**LOUISIANA 1 IMPROVEMENTS  
GOLDEN MEADOW TO PORT FOURCHON**

**REVISED RECORD OF DECISION  
MARCH 2009**

## **RECORD OF DECISION (REVISED MAY 2004 & MARCH 2009)**

*(SUMMARY: The Record of Decision (ROD) signed January 2003 and revised May 2004 is being revised again to include updated minor refinements (planned, designed or under consideration) in the project, particularly for Phase 2.)*

LA1 Improvements - Phase 2  
Revised Alignment - Leeville to Golden Meadow

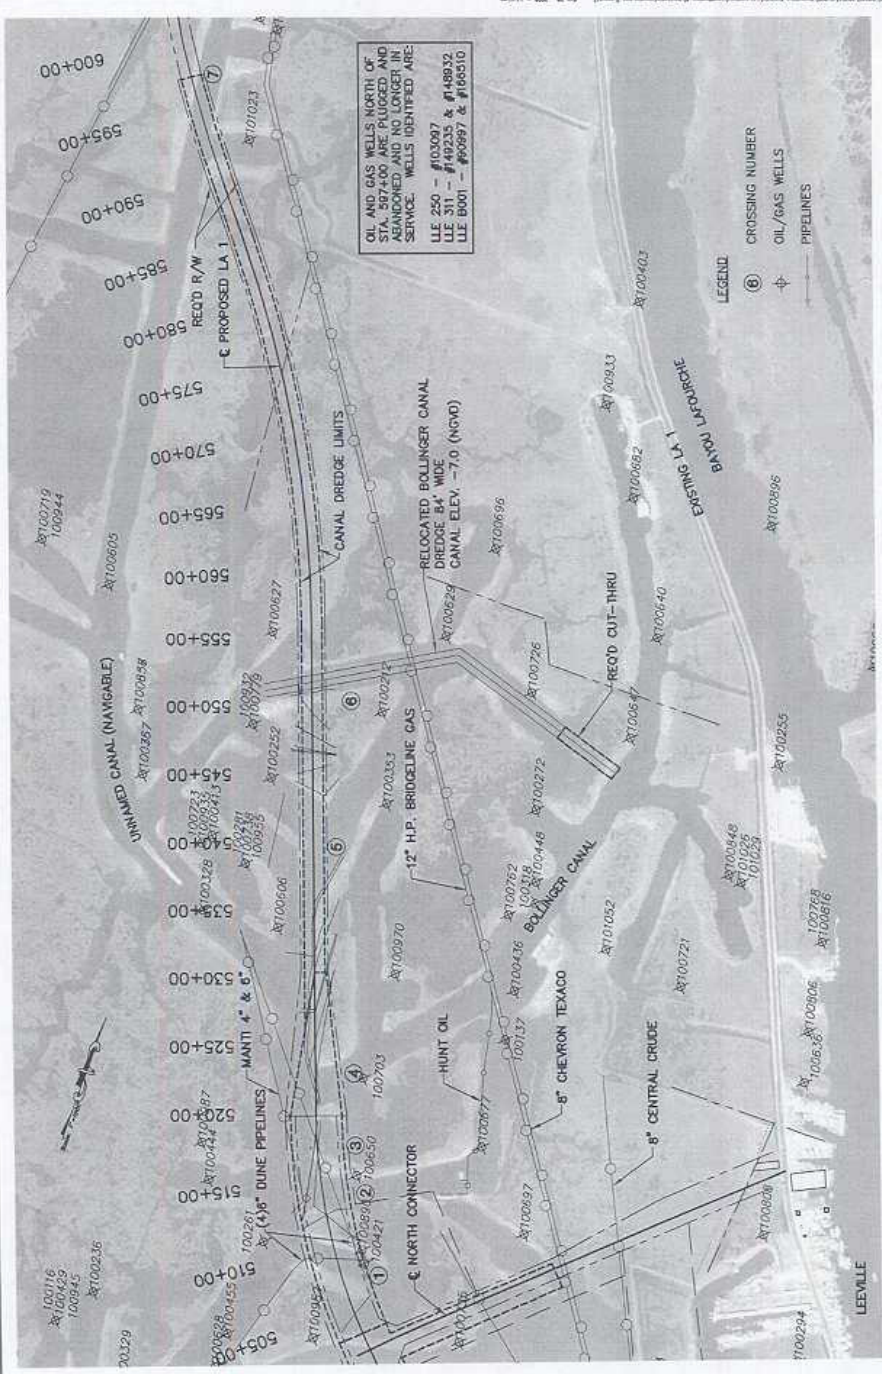
revision to the ROD. Three existing transmission pipelines would require over 1000 ft. of pipe relocation. Pipeline relocations would be costly, impact existing coastal marsh and would be potentially harmful to the environment. It was determined that the alignment should be relocated approximately 1200 ft. westward to avoid conflicts with the pipelines in this location. In addition to eliminating these pipeline relocations, the shift reduces the number of pipeline crossings. For comparison purposes, the attached exhibit in the appendix entitled, “LA1 Improvements-Phase 2, Revised Alignment-Leeville to Golden Meadow” shows both the original alignment and the shifted alignment.

**LA 1 IMPROVEMENTS  
 GOLDEN MEADOW TO FOURCHON  
 LAFORCHE PARISH  
 JOINT USE PERMIT APPLICATION  
 NAVIGABLE CROSSINGS**

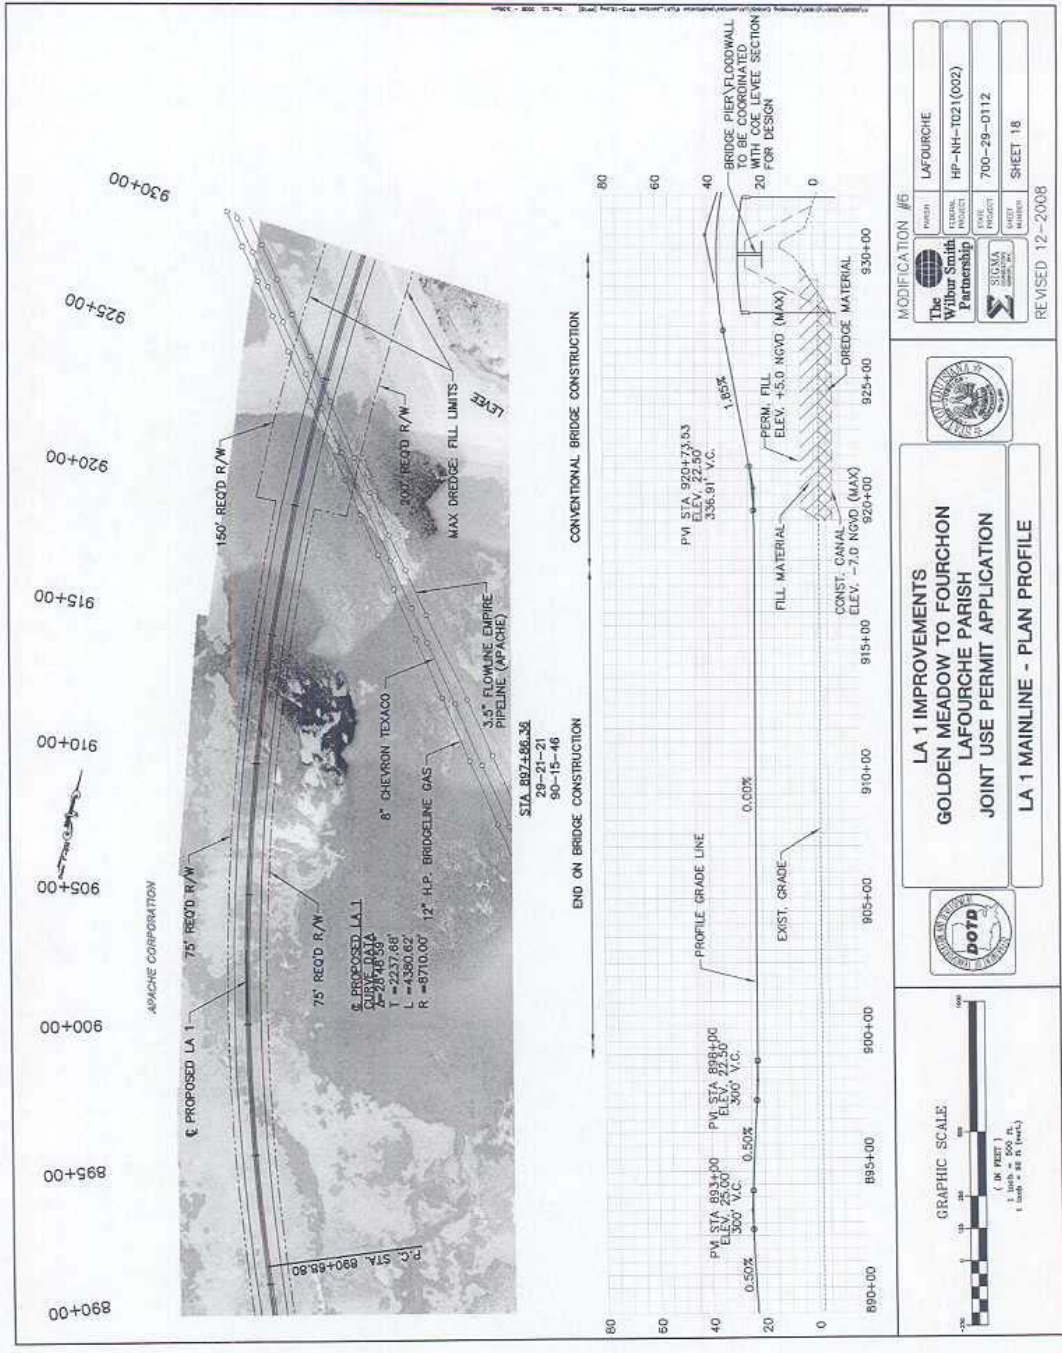
An alternative crossing location has been identified that would require minor dredging in order to maintain existing accessibility to the oil and gas facilities. The relocated Bollinger Canal will have a 55’ vertical clearance and 65’ minimum horizontal clearance. Both the US Coast Guard (USCG) and the landowner agreed with the alternative crossing location. All existing canals could potentially be accessed with this layout. Attached hereto in the appendix is “Figure 26” from the permit application which shows the location of the alternative crossing and its relationship to the canals in the area. The clearances for the other seven canals will be determined in the final design of Phase 2. All seven crossings were discussed with the USCG who requested that the crossings be identified and included in the future USCG permit, as an approved span arrangement has not yet been determined. Several wells were identified as having access from canal 7. Although access to these wells will be impacted by the construction of the project, the wells all appear to be plugged and no longer serviceable.

investigate a canal crossing to this field that would provide 55' of clearance, the same clearance that was negotiated in Phase 1. It was explained that due to the north connector being located so close to the Bollinger Canal, the 55' clearance cannot be obtained at the existing location of Bollinger Canal. Therefore, the project team proposed dredging and extending one of the other canals in the area to maintain access to the area. The proposed location for 55' clearance is labeled Canal "6" on the figure in the appendix.

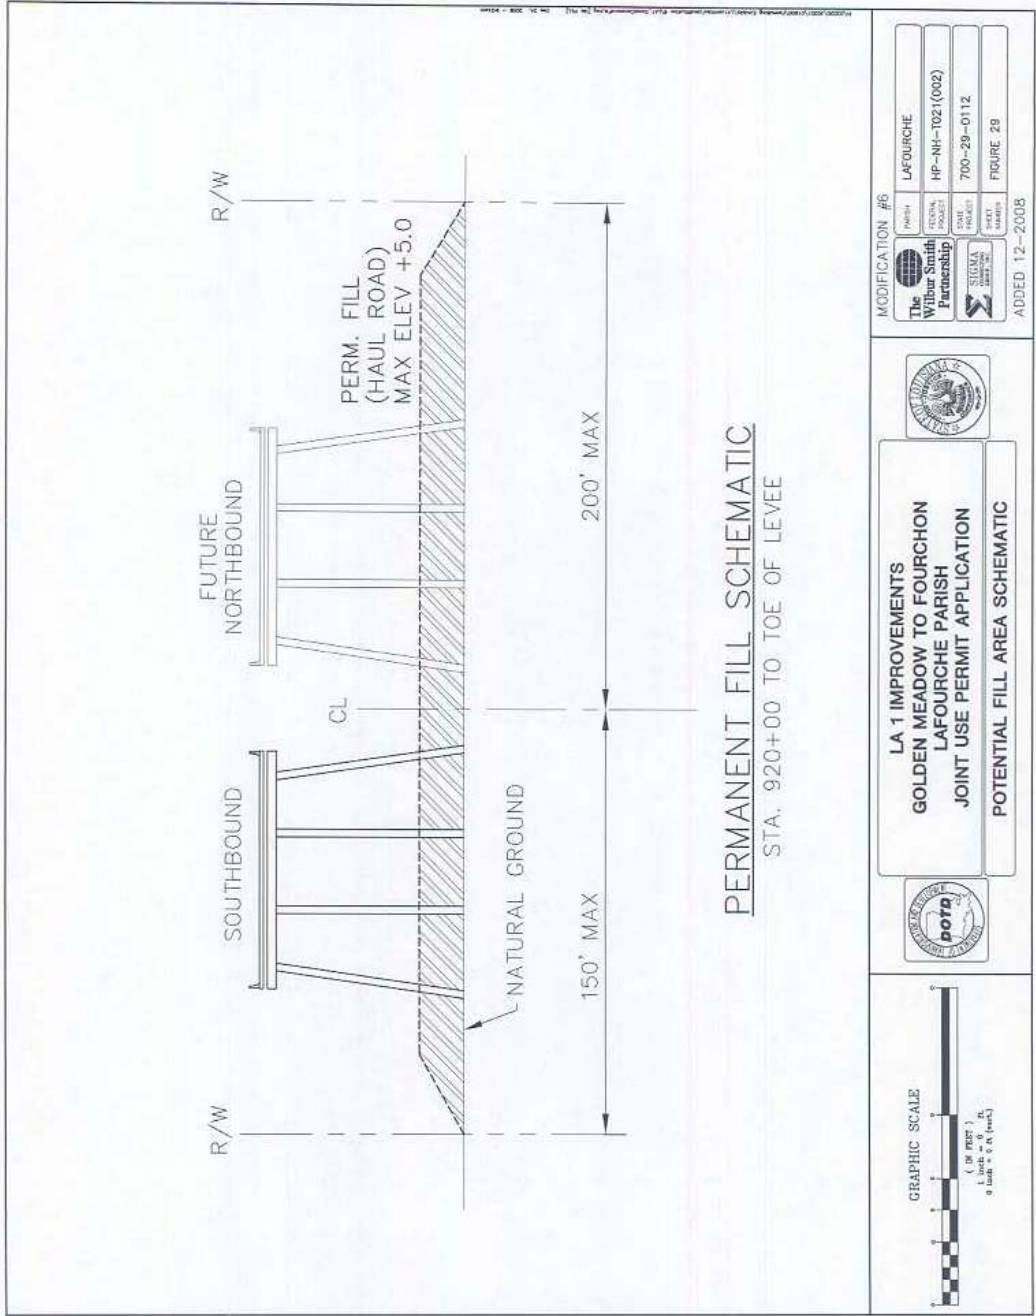
Based on this information, the design team is recommending steel spans crossing the levee structure with a pier in the levee crown. The pier will also serve as a flood protection wall to accommodate the COE and South Lafourche Levee District's flood protection needs. The entire superstructure of the bridge will be above the anticipated +25.5 ft elevation. Also, in order to facilitate construction of the high level crossing of the levee, either construction canals or a haul road is anticipated. Several figures in the appendix depict the impact of either option, the construction of canals or a haul road. The first figure is sheet 18 from the permit application and is entitled, "LA 1 Mainline – Plan Profile." This sheet shows the plan and profile for both options at the levee. The next sheets, Figures 28 and 29 from the permit application, show typical cross sections. Figure 28 is entitled, "Typical Canal Section" and depicts the cross section for the dredge option. Figure 29 is entitled, "Potential Fill Area Schematic" and depicts the cross section for the haul road option.

In order to allow the contractor to determine the most cost efficient method of construction, a haul road could be also anticipated between Sta. 920+00 and Sta. 928+00± (toe of levee) near the Golden Meadow Hurricane Protection Levee. The haul road is being permitted as permanent fill to elevation +5.0 NGVD in order to provide protection to the existing levee and also serve as a wave berm. The anticipated permanent fill quantity for the haul road is 31,000 yd<sup>3</sup>. This will increase the total project permanent fill from 51,000 yd<sup>3</sup> to 82,000 yd<sup>3</sup>. The total fill quantity for this project will be increased from 386,000 yd<sup>3</sup> to 417,000 yd<sup>3</sup>.
